RE: ADDENDUM NO.1 to the Bidding Documents for:

Exterior Wall Renovation:

ARROYO SECO COMMUNITY CENTER Taos County: **Taos County Bid No. B-2009-16**

Taos, New Mexico Project No. J090900

Sheet A11/4 - Wall Sections

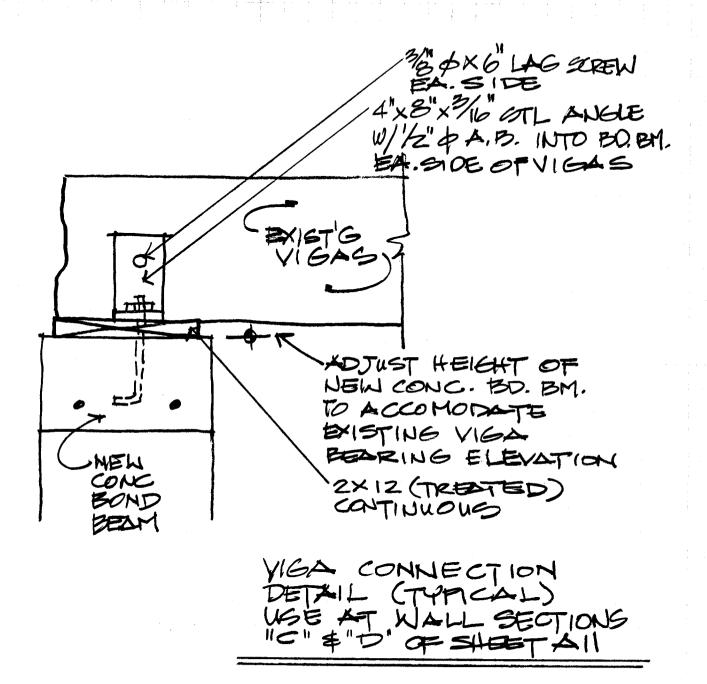
Provide for the following attached Detail at Wall Sections "C" and "D" for Existing Viga Connection.
